MIL IS ON WITH BLOWN FUSE 15**TECHNICAL SERVICE BULLETIN**

Reference Number(s): 99-029, Date of Issue: April 20, 1999

HONDA: 1996-1999 Civic

Fig 1: Intake Manifold Bracket

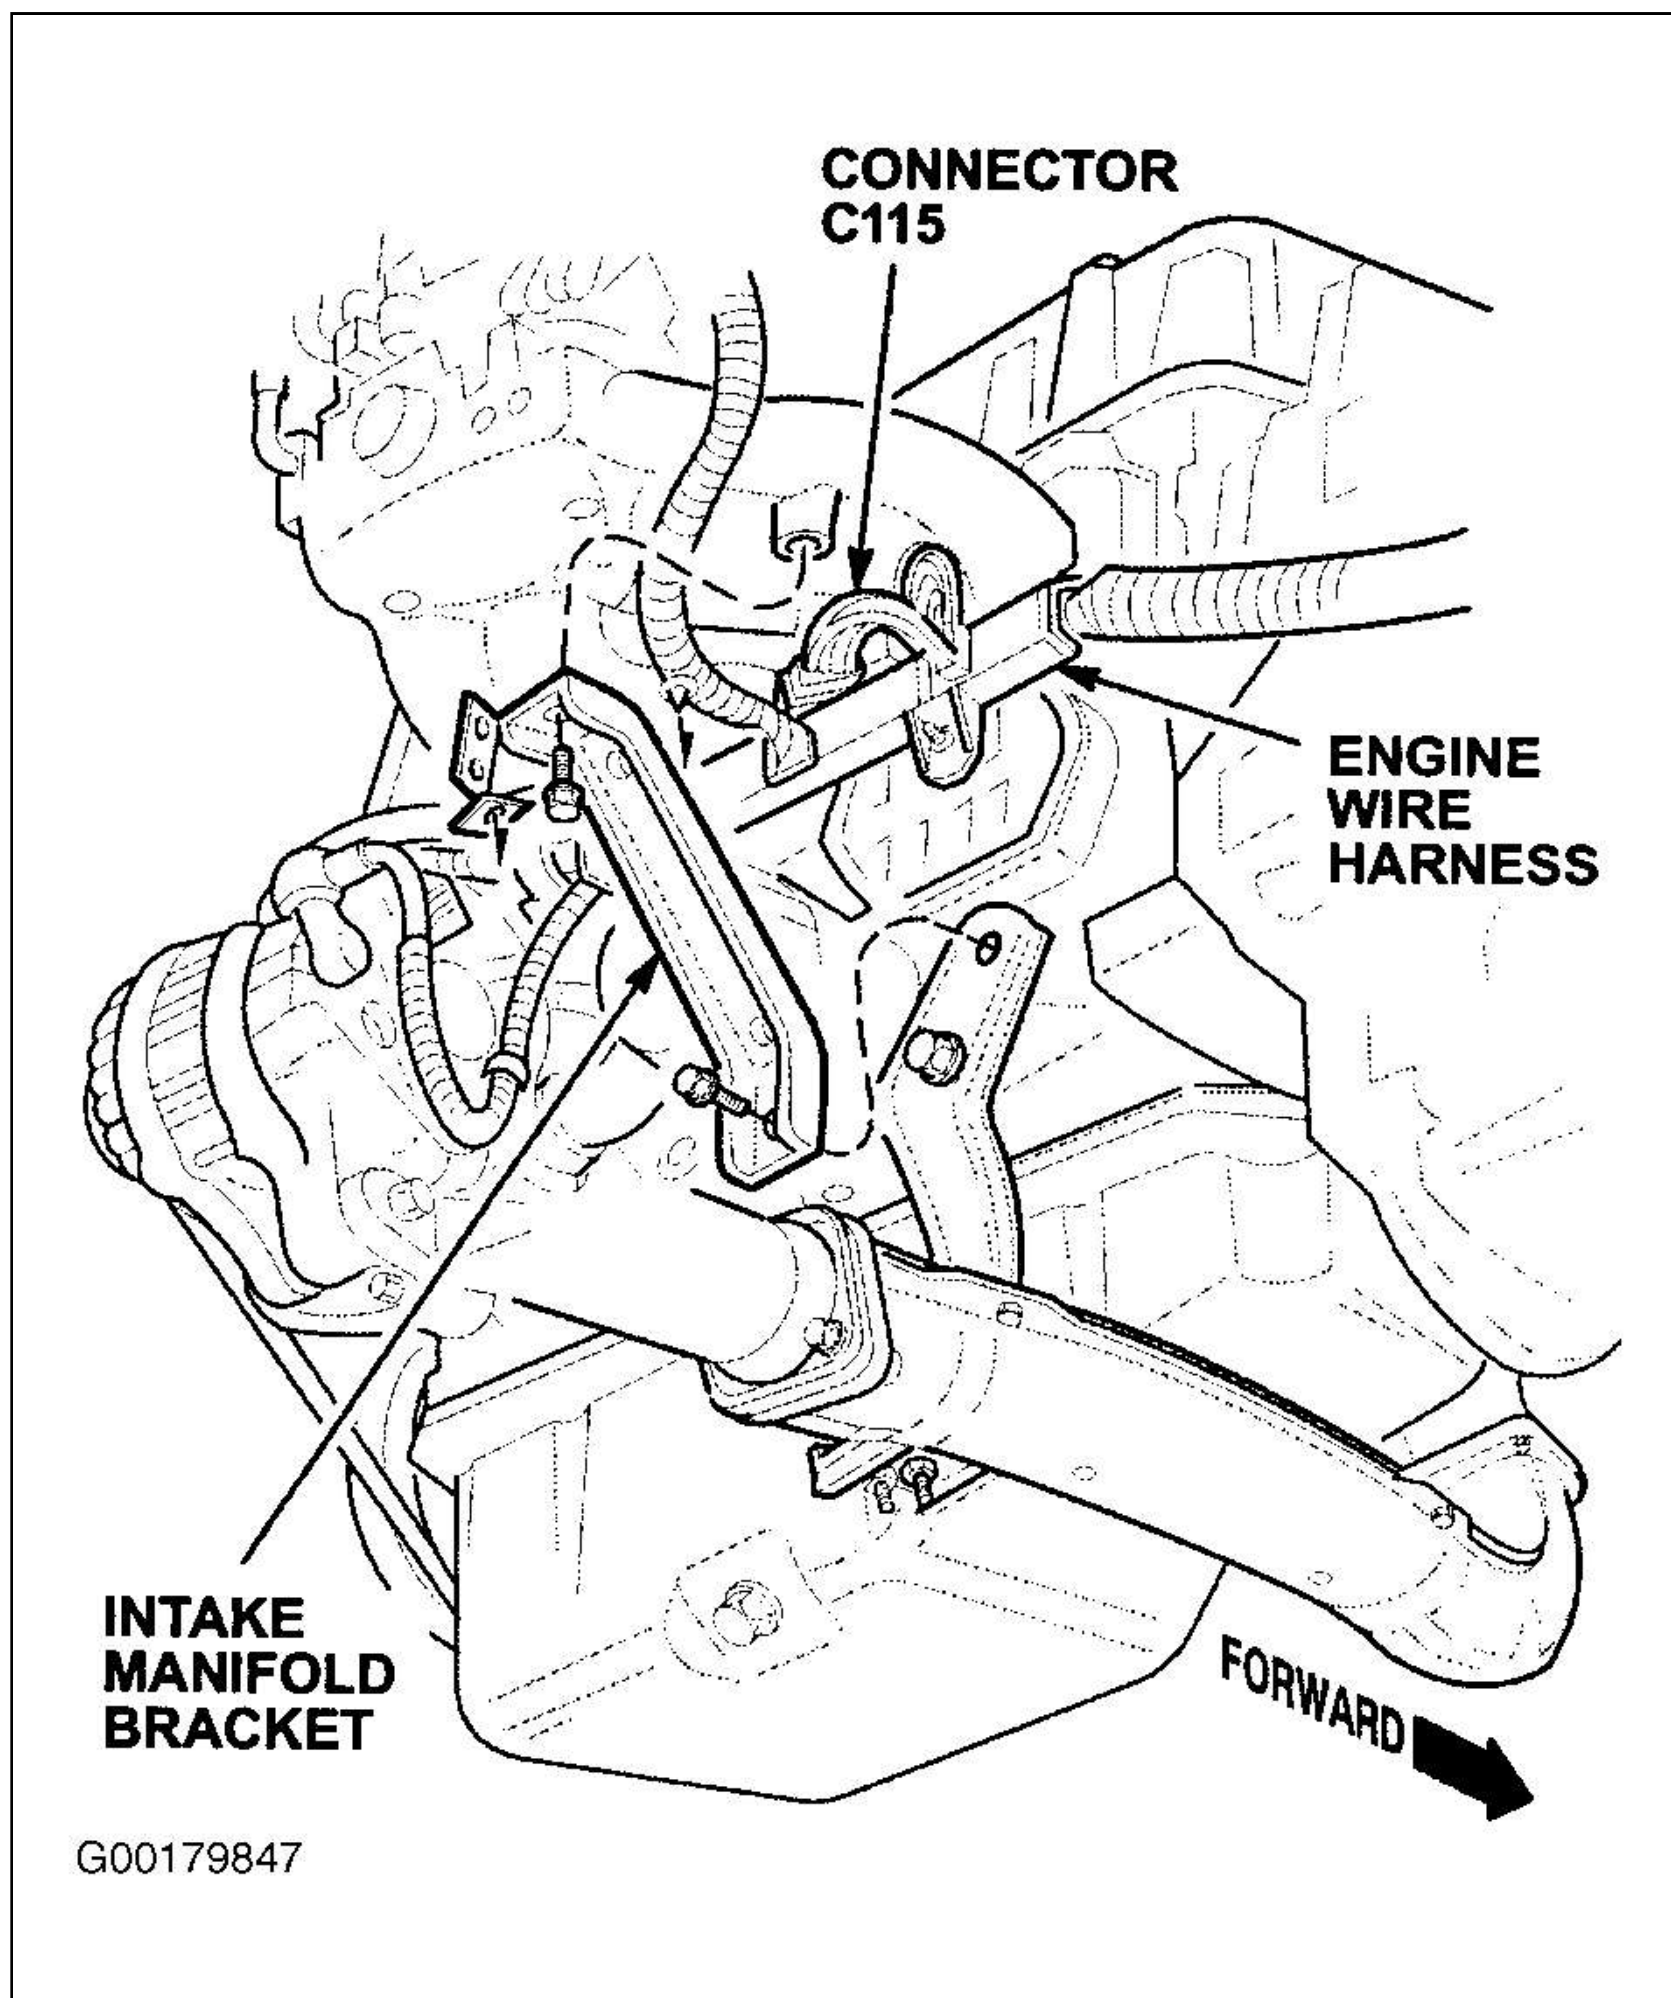
The engine wire harness is rubbing on the intake manifold bracket.

4. Remove the intake manifold bracket. See Fig 1 .

5. Disconnect the engine wire harness from the intake manifold bracket.

Fig 2: Installing Corrugated Tubing

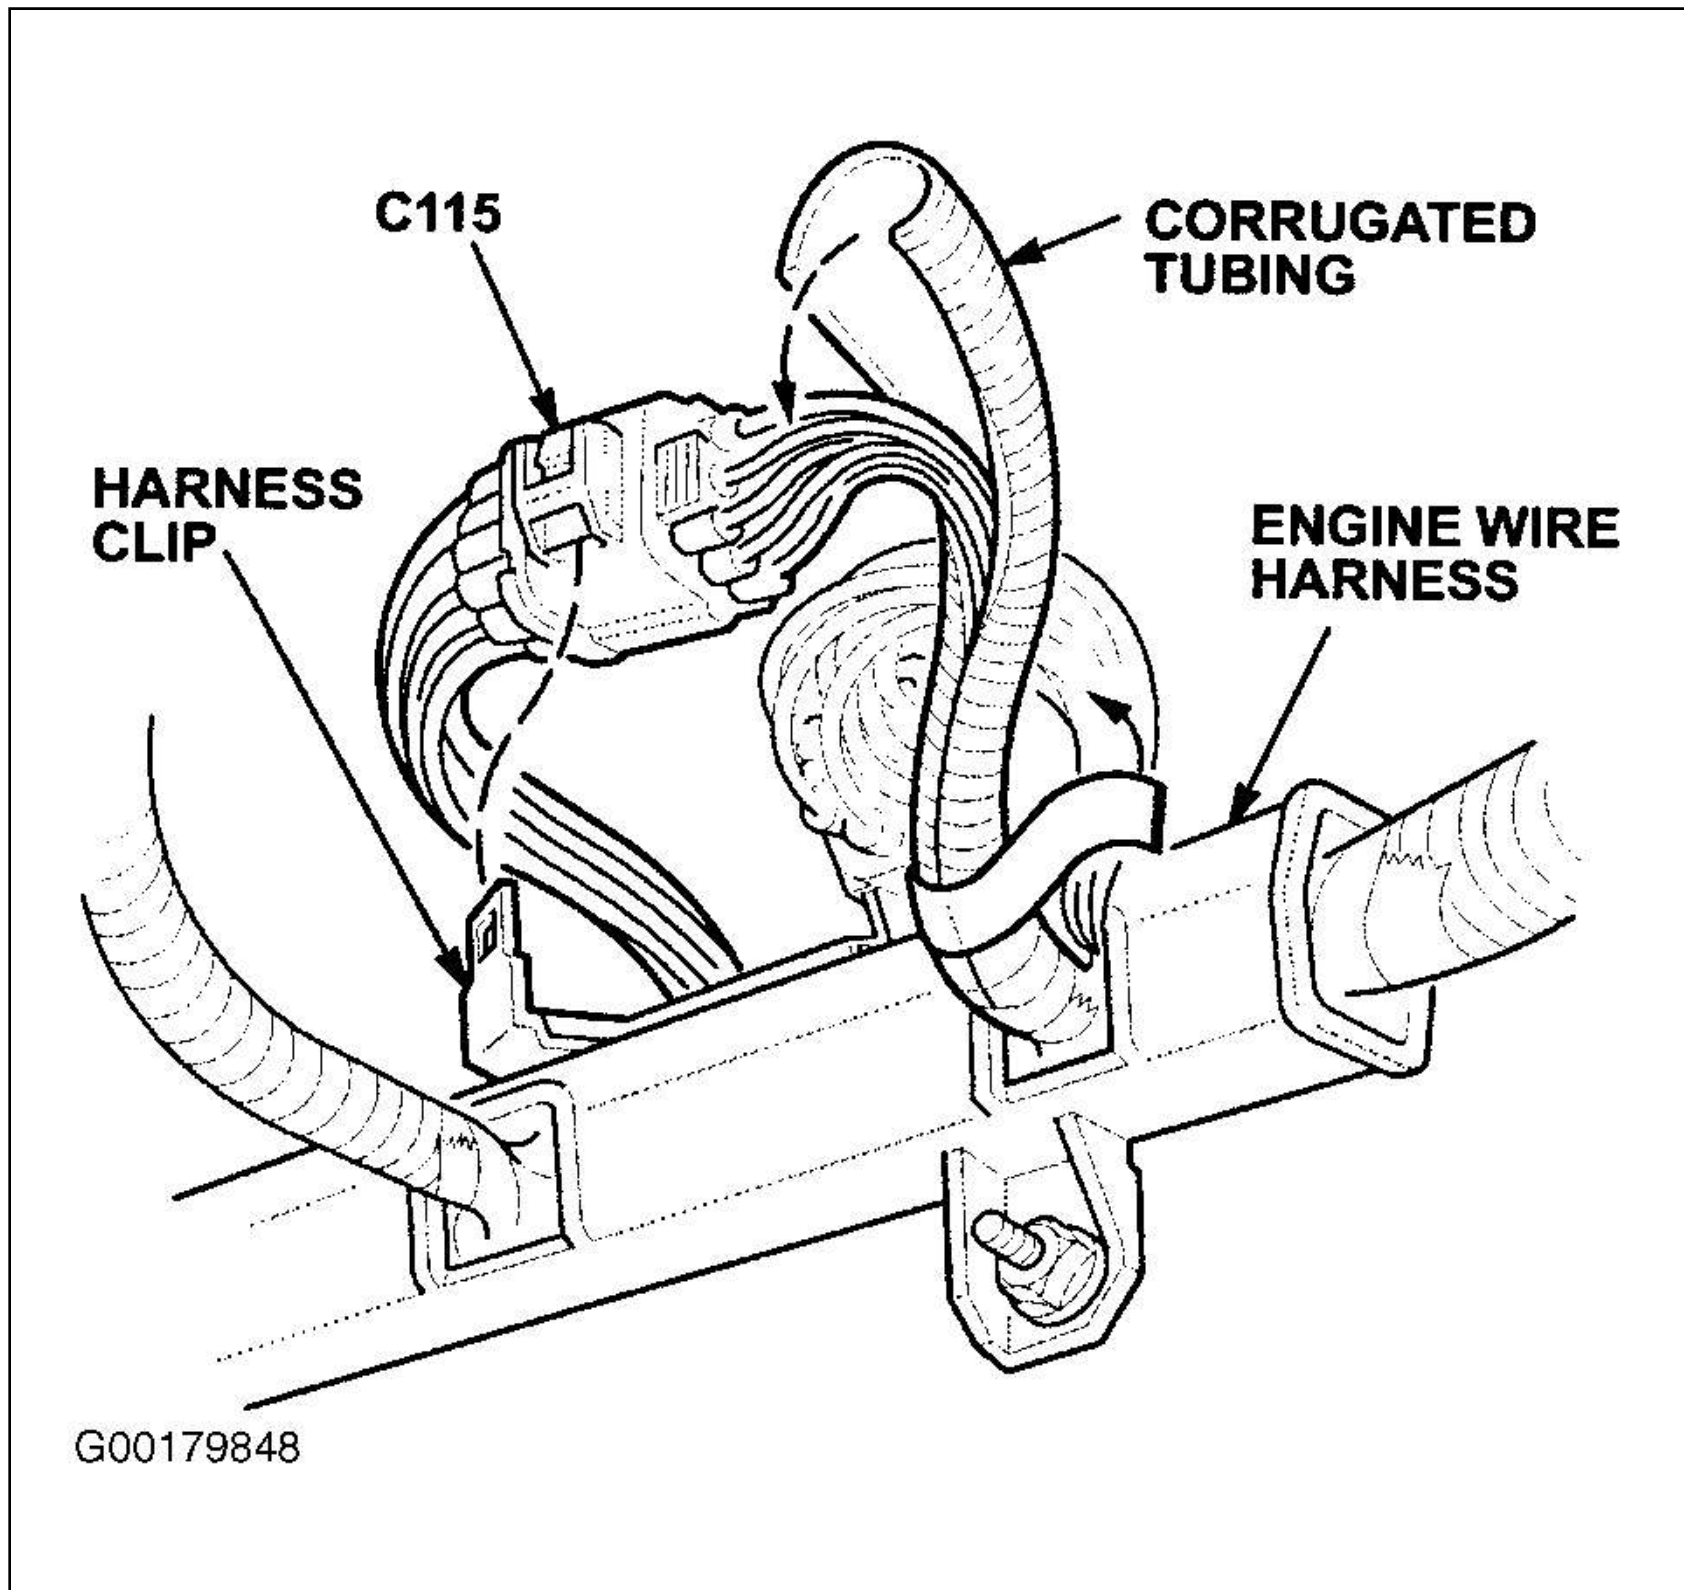
7. Install the corrugated tubing over the harness. Tape the tubing to the harness to hold it in position. See Fig 2 .

8. Reinstall the engine wire harness to the intake manifold bracket. Reinstall the bracket to the engine. Torque the bolts to 24 N.m (17 lb-ft).
9. Lower the car.
10. Reconnect the negative battery cable.
11. Enter the customer's radio station presets. Set the clock.
